RE: GARCIA VOLKSWAGEN (J19/D003)

Attached with this letter is a copy of the revised Drainage and Grading submittal for your review. Revisions include general adjustments based on site plan changes and clarifications. The following bulleted items are in response to your review comments dated June 21, 2012 on a point-by-point basis:

EXHIBIT A

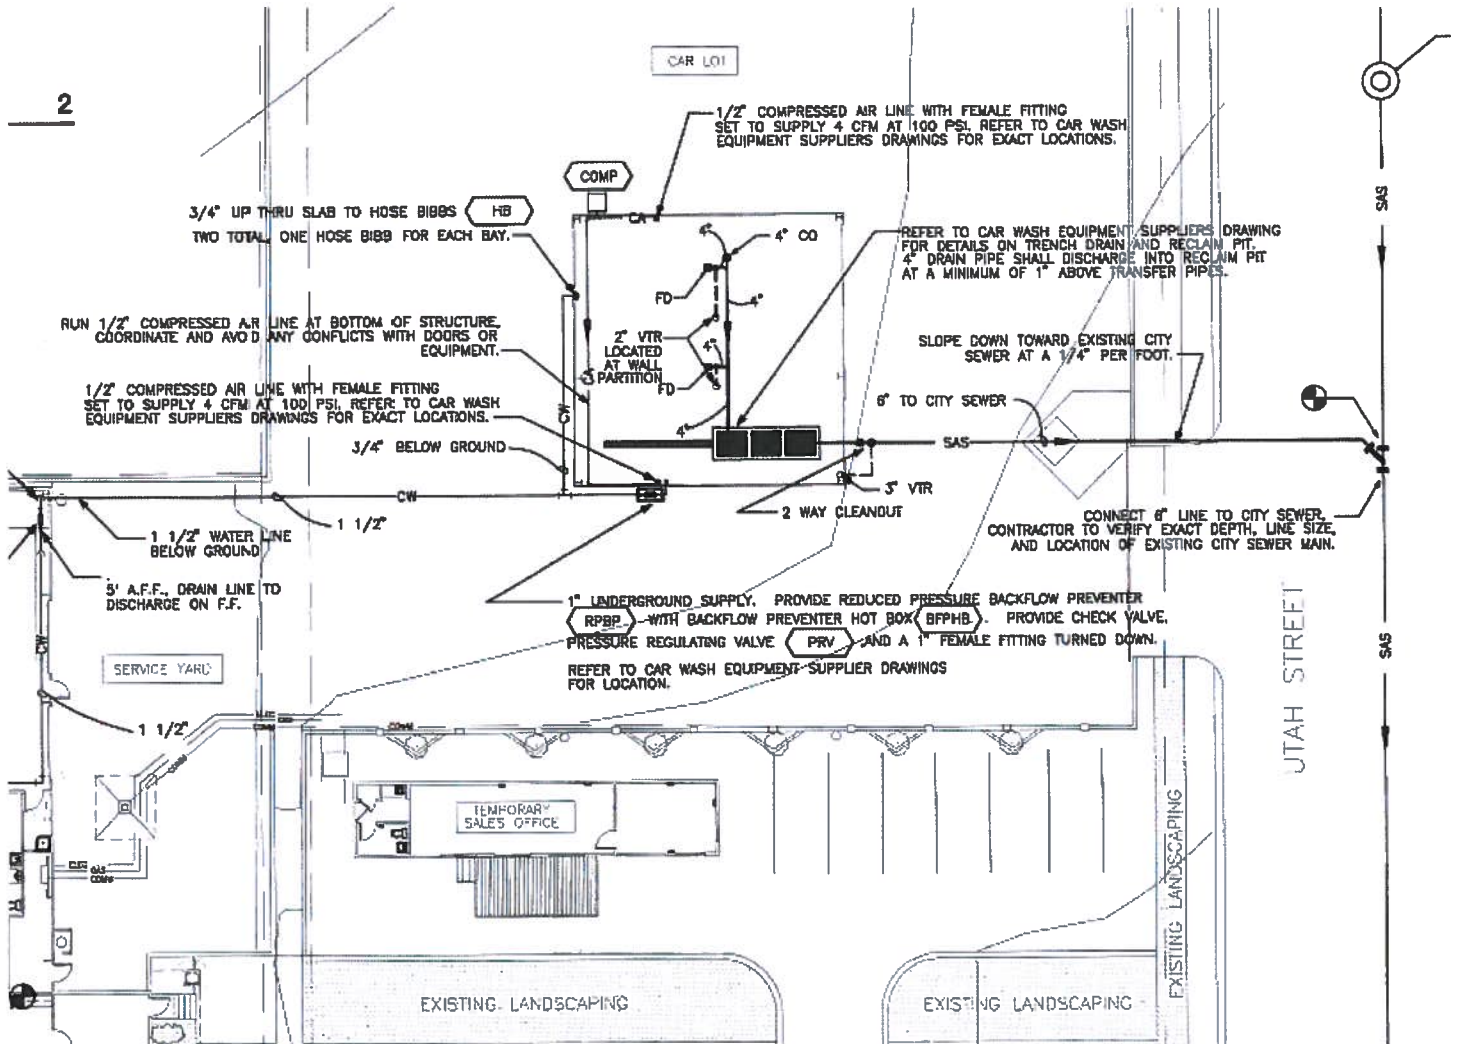
1. Based on the construction documents for the existing car wash, the car wash area drains to the sanitary sewer system. See attached Exhibit A for the SAS design from the original plan set.
